From: [redacted]
Sent: 14 May 2025 16:15
To: Katherine Williams
Cc: [redacted]
Subject: RE: DM/25/0643, 0674 and 0770 - 142 High Street, Hurstpierpoint
Attachments: 142 High Street brick and French doors.pdf

Subject: RE: DM/25/0643, 0674 and 0770 - 142 High Street, Hurstpierpoint

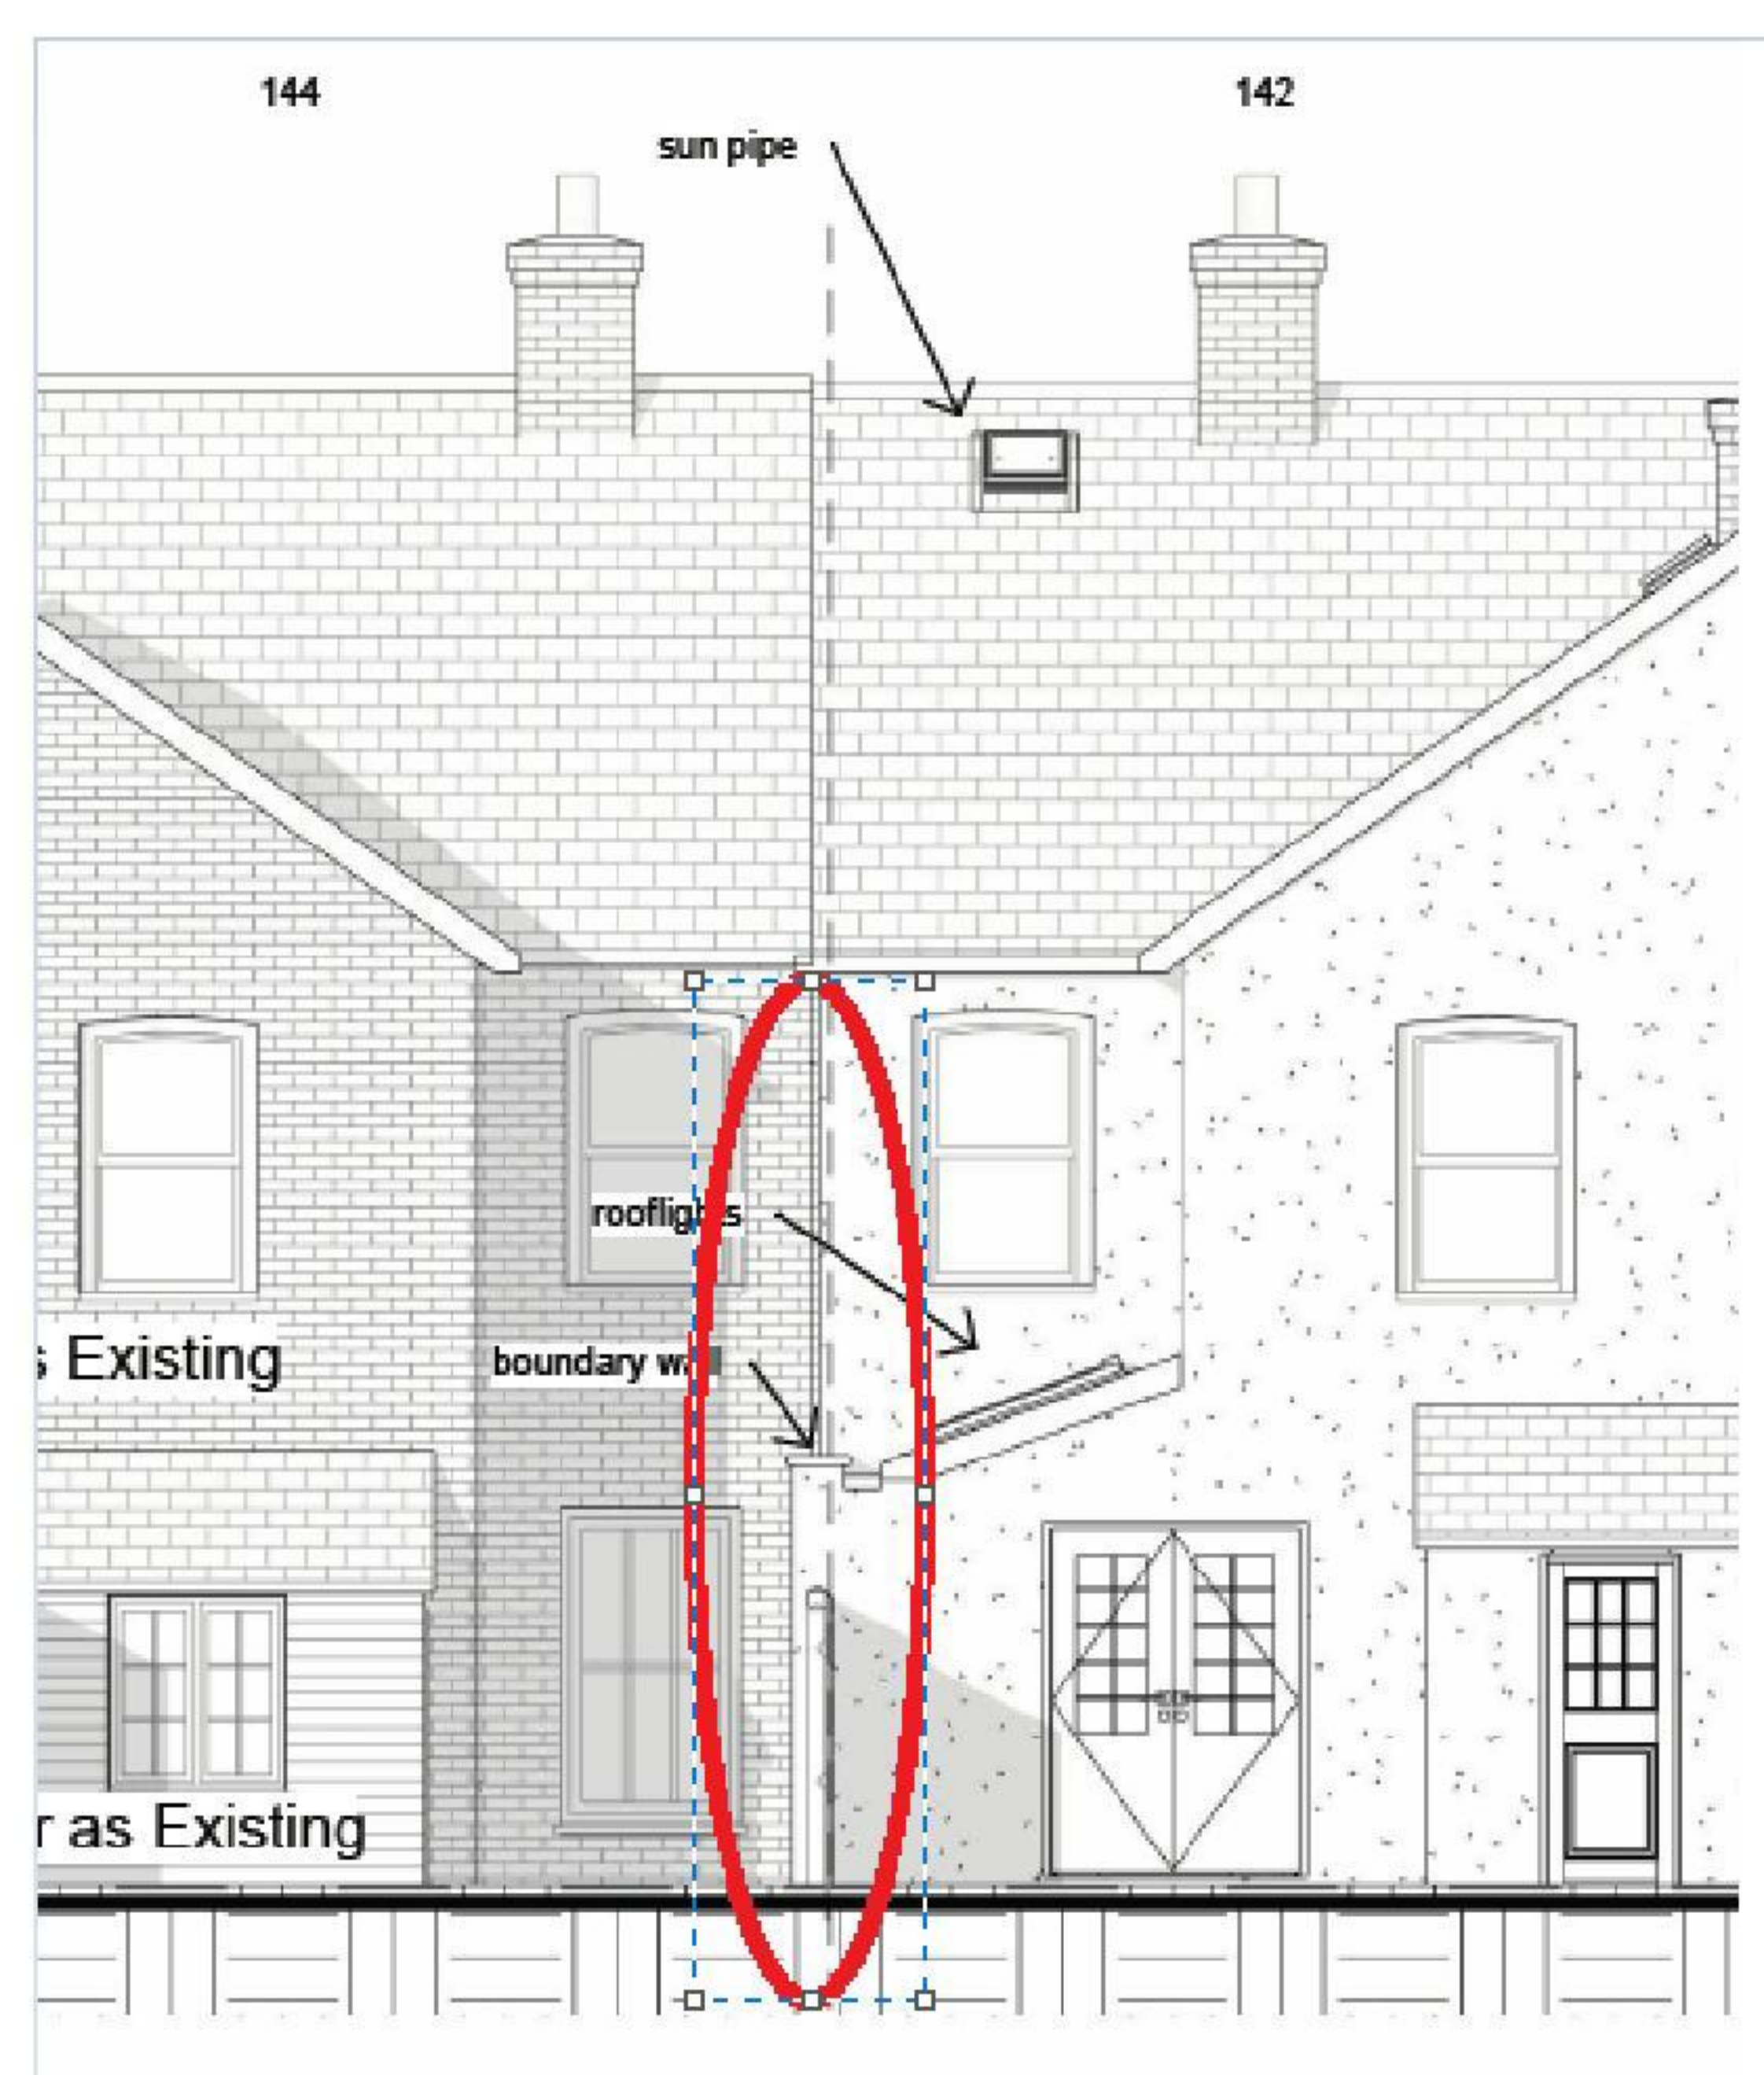
In terms of Certificate B I have considered the comments within your email, however I do not agree. The application property and the attached neighbour are mirroring properties with the boundary centrally between the properties, as viewed on site. The side wall of the extension would extend over this boundary onto No. 140. This is clearly shown on the plans provided with the boundary identified by a black line on the elevation plan and on the floor plan with No. 140 greyed out. This is highlighted below.

The requirement to give notice to all owners of the land which the application relates is set out within Section 13 of the Town and Country Planning (Development Management Procedure) (England) Order 2015 and until the correct certificate has been provided or the proposal amended to solely be within the boundaries of No. 142 the application will remain invalid.

North as Proposed

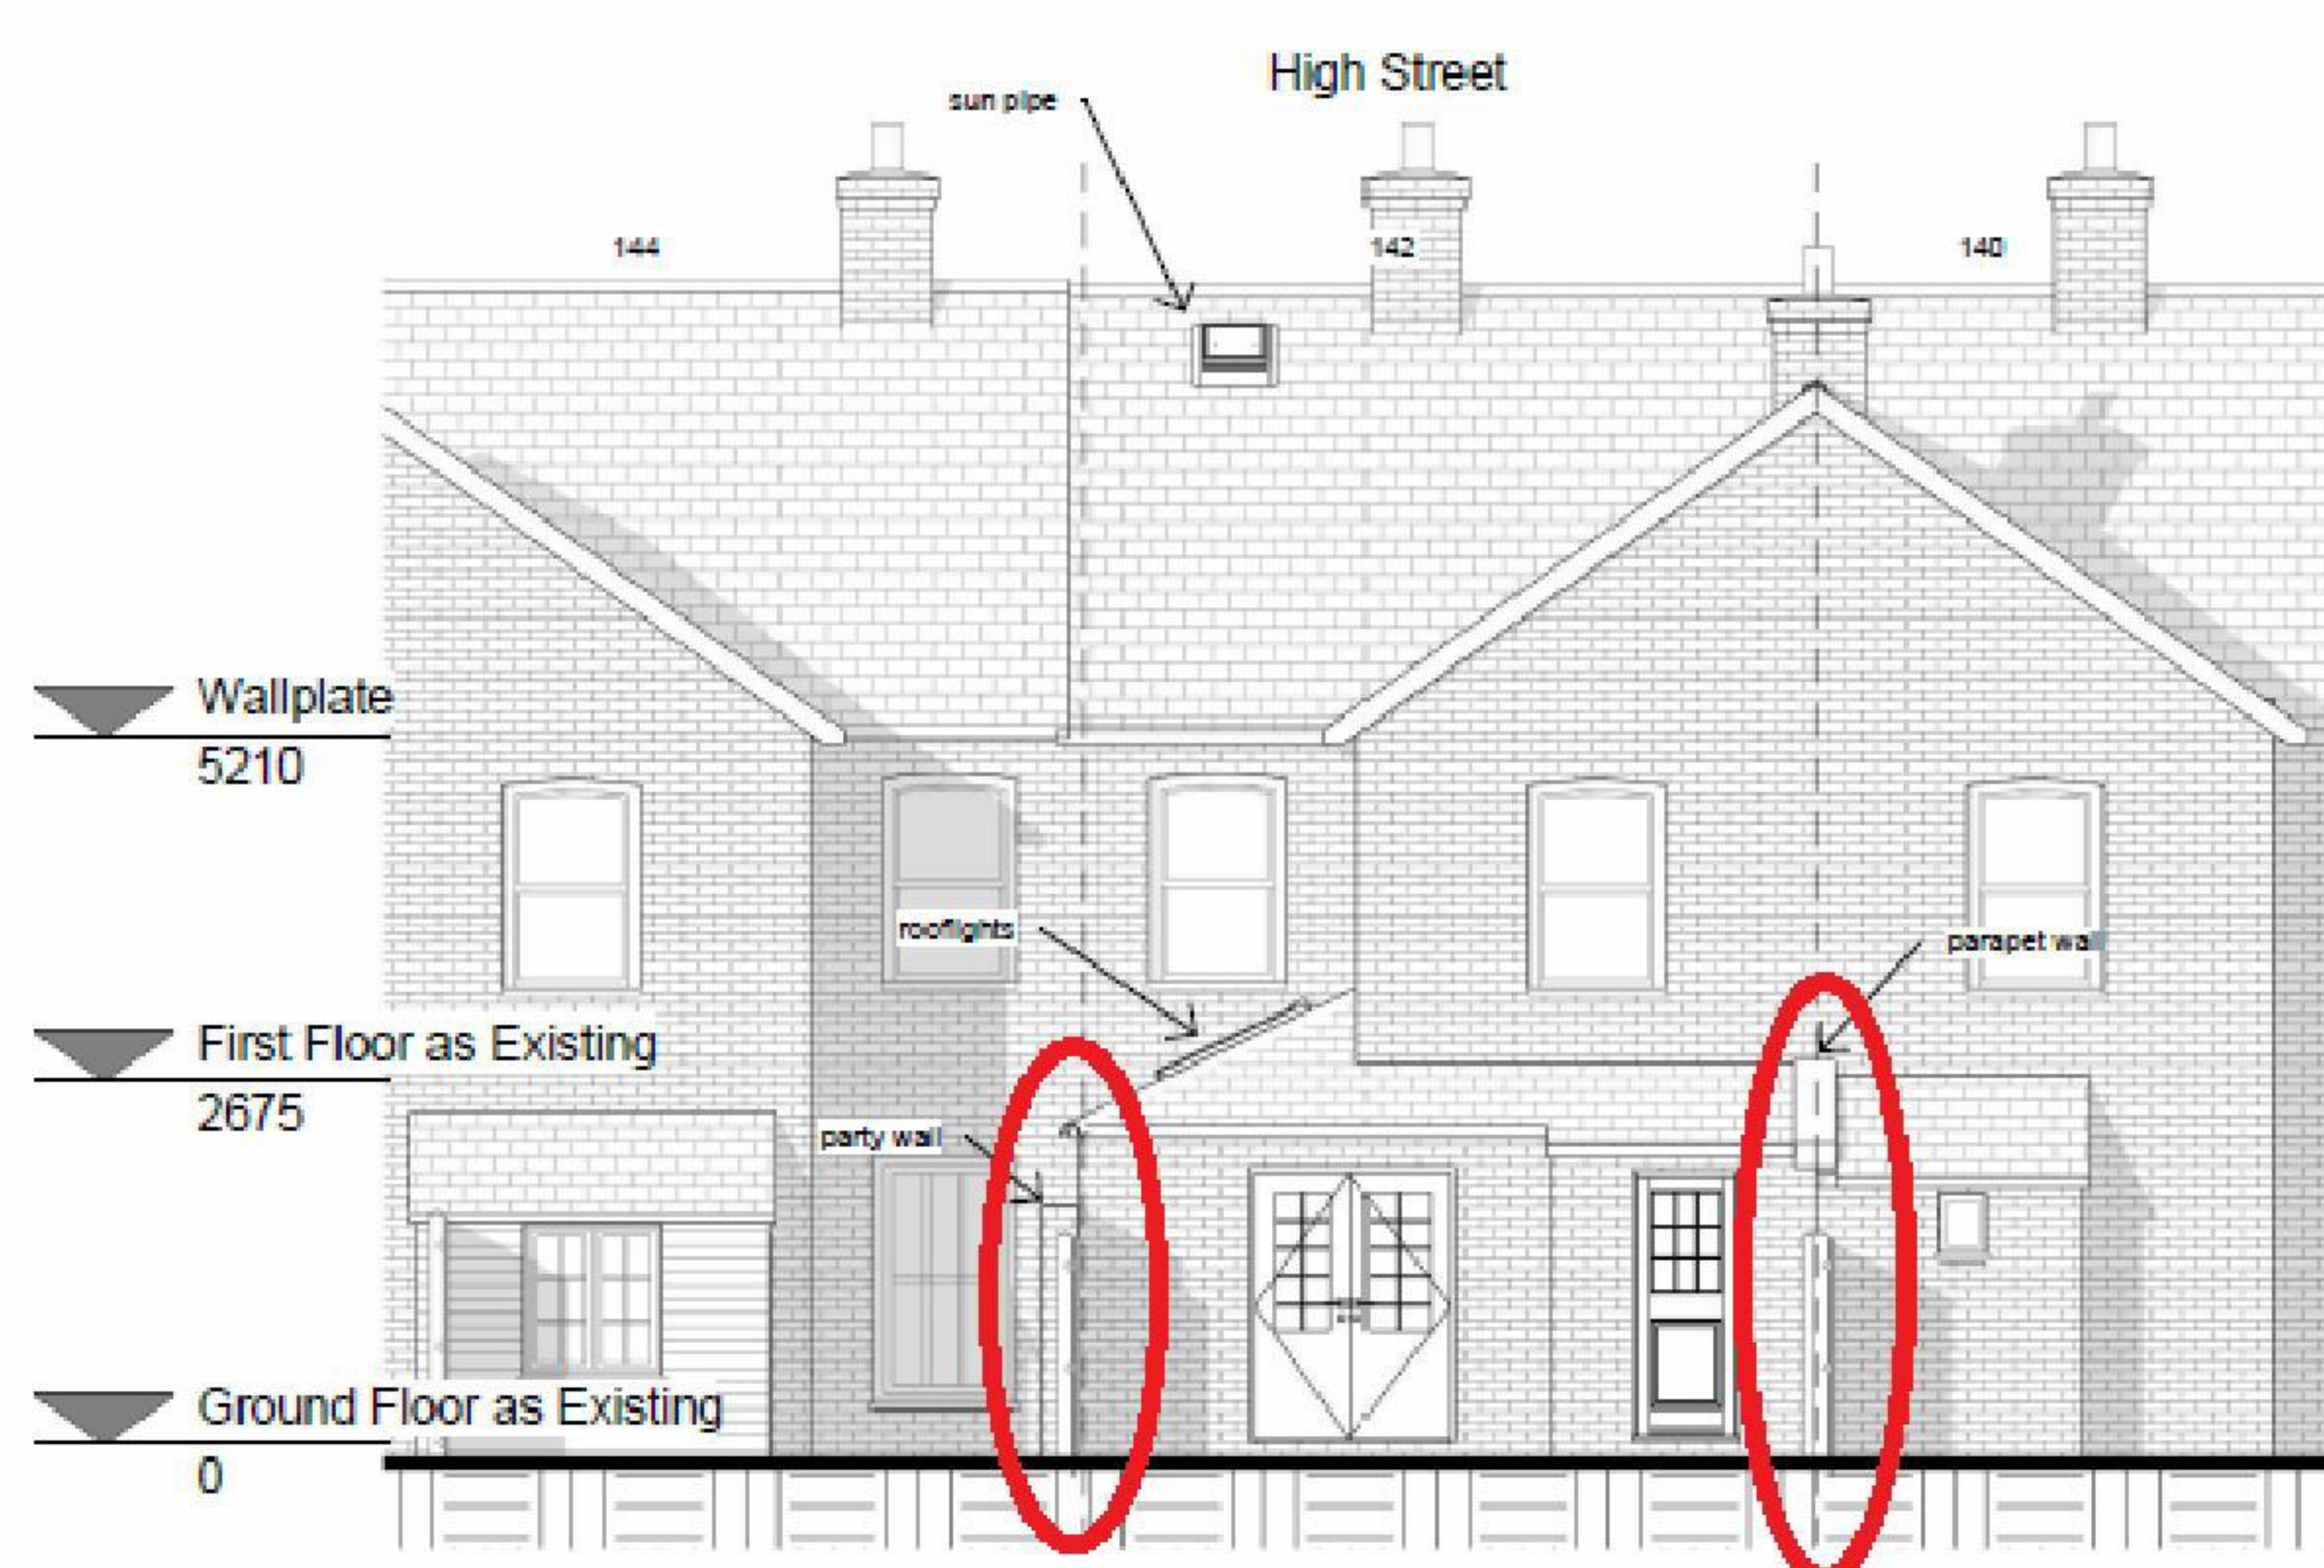
The proposed wrap around form of the extension would result of the dilution of the original 'T' shape of No.s 142-144 and result in a loss of symmetry between the pair. This concern was raised under a pre-application with my colleague Stefan Galyas. It is therefore recommended that the proposal is amended to reflect the advice given within this pre-application.

In addition to this, the proposed plans indicate that the proposal would extend over the boundaries with both No.s 144 and 140, however certificate B has not been completed to give notice to these neighbouring properties. Due to this, it is currently considered that this application is invalid.

Thank you for your comments. I have taken instruction from the Client and submit for your consideration the attached revision. The Client would like to comply with Ms Wade's comments. The extension is stepped back, the outrigger is maintained with a new door exit.

The boundary wall is notably within the application site curtilage, which is apparent compared to the first floor and roof profiles. The wall only aligns with the application site and does not sit between the boundaries.
